RE: Ironwood Real Estate, LLC/Etown IRE Associates, LLC
1551 South Market Street - Subdivision Plan

Lancaster Civil September 18, 2025 Review Letter

PRELIMINARY/FINAL SUBDIVISION PLAN

Re: Ironwood Real Estate, LLC (1551 South Market Street)
Minor Subdivision Plan
Township Permit No. 25-16-MSDP
LCEC Project No: 25-203

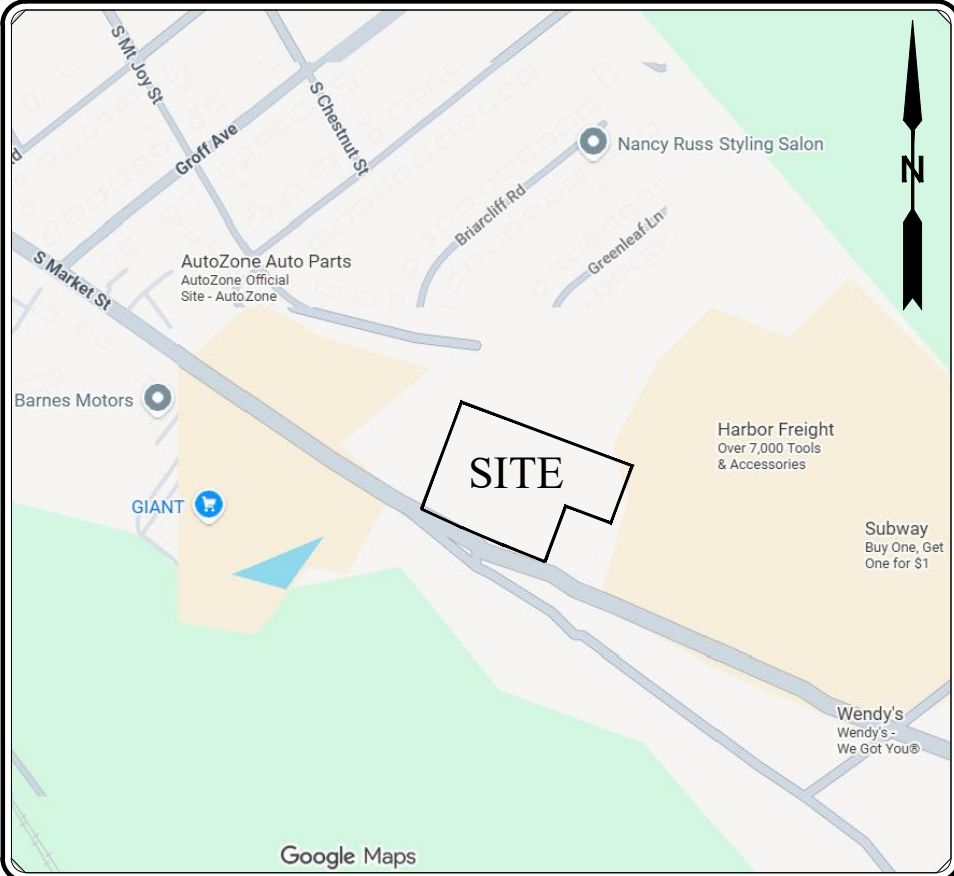
1. The maximum height requirement shall be added to the Zoning Data table (135-135.A).

2. All off-street parking lots shall be set back at least 15 feet from the side and rear lot lines (135-135.E(2)(c) & 135-135.E(3)(b)). These setbacks should be shown on the plans.

4. Clear sight triangles and stopping sight distances shall be shown at the existing access points (135-299.E(2) & 119-31.D(12)).

5. Riparian corridors shall be established to include 30 feet on each side of the watercourse, measured from the top of each stream bank (135-306.B). The applicant shall enter into a recordable agreement with the Township providing for the permanent maintenance of the riparian corridor, in a form acceptable to the Township Solicitor (135-306.F).

10. The application indicates that this is a "Minor Subdivision Plan" however since this subdivision involves non-residential uses, it must be processed as a standard subdivision plan (119-25.C(4)(a)). The plan title shall be corrected to reflect that this is a standard subdivision.

1. The maximum height requirement shown in the Zoning Data table shall be corrected (135-135.A).
2. The existing impervious coverage exceeds 65%. This is an existing non-conformity. However, the proposed impervious coverage for Proposed Lot 1 (75.8%) exceeds the existing, non-conforming impervious coverage (70.7%); this would require a variance from the Zoning Hearing Board (135-135.F(2)).
3. Clear sight triangles and stopping sight distances shall be shown at the existing access points (135-299.E(2) & 119-31.D(12)). The applicant appears to have requested a waiver of this requirement since this requirement is listed in the "List of Waivers" on the Cover Sheet; however the response letter does not state a waiver is being requested.

5. The total required number of spaces for the retail store use (i.e. shopping center) shall be corrected (135-343.C). For 33,870 sf of gross floor area, 169 parking spaces would be required (5 spaces per 1,000 sf of floor area). The required number of parking spaces may be reduced by 20% for joint parking lots (135-344.A)
6. A calculation showing the number of seats and employees shall be provided for the parking space requirements for the Drive-Through Restaurant use (135-343.C(5)).
7. A cross access easement and maintenance agreement that ensures the common use of, access to, and maintenance of the joint-use parking lot for proposed lots 1 and 2. The agreement shall be provided in a form acceptable to the Township Solicitor (135-344.C).
8. Off street loading space information shall be shown on the plans (135-346).

25. The proposed property corners symbols shall be labeled to differentiate between the different types of corners to be set (119-57.B & 119-57.D). It currently appears that concrete monuments are to be set at each corner; however, there are three different “proposed property corners” symbols shown in the legend.

The maximum height requirement has been added to the subdivision plan.

The parking setbacks have been added to the subdivision plan.

There are no changes proposed to be made to the site or the access points. The existing conditions will remain.

A proposed riparian corridor has been added to the subdivision plan. The applicant will enter into a riparian corridor maintenance agreement prior to subdivision plan recording.

The subdivision plan title has been revised to "Preliminary/Final Subdivision Plan".
